ARCHITECTURAL REVIEW COMMISSION MEETING AGENDA

To: Architectural Review Commission (ARC)
From: Andy Hulka, Associate Planner
Date: December 19, 2018
Subject: SPL-18-009, Dugala Distillery, 7321 S. Canyon Centre Pkwy

To: CH Architectural Review Commission (ARC)
From: Matt Taylor, Senior Planner
Date: December 19, 2018
Subject: Project CUP-18-012; Canyon Centre Courtyard by Marriot Hotel

North Elevation Comparison

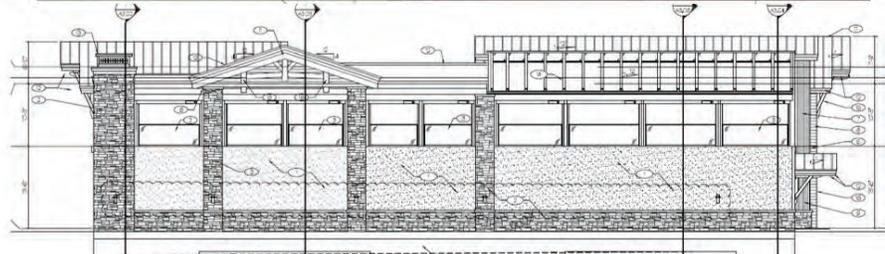
- Outdoor dining
- Glass around front entry
- Primarily stone veneer on wall

- Retractable glass roof
- Glass removed from entryway
- Stone veneer and stucco on wall

The revised plans have been reviewed for compliance with the city design guidelines and the original conditions of approval and appear to be generally compatible with the overall character of the Gateway Overlay District. Staff recommends the ARC review the design and materials on the north elevation to assess whether additional conditions are appropriate. Staff also recommends the ARC discuss the design of the retractable roof and window system. Prior to the issuance of any permit for building and/or site work, staff will review final plan submittals for compliance with applicable city ordinances.

East Elevation Comparison

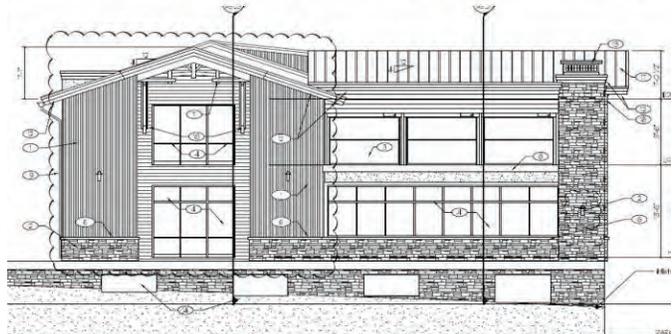
- Outdoor dining
- Stone veneer around windows

- Indoor dining with new window system
- Wood siding around windows

West Elevation Comparison

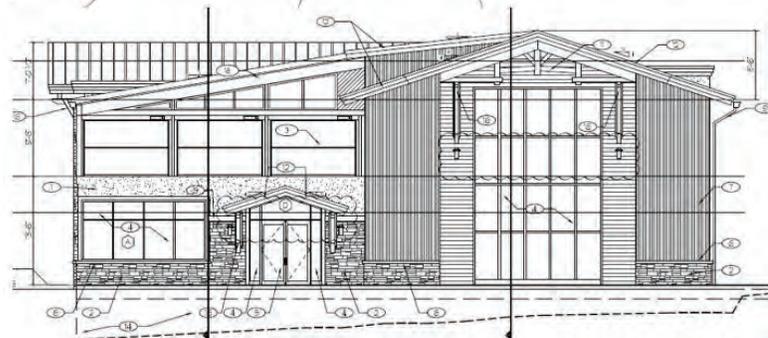
- Outdoor dining
- Glass around front entry
- Stone veneer around windows

- Indoor dining with new window system
- Wood siding around windows
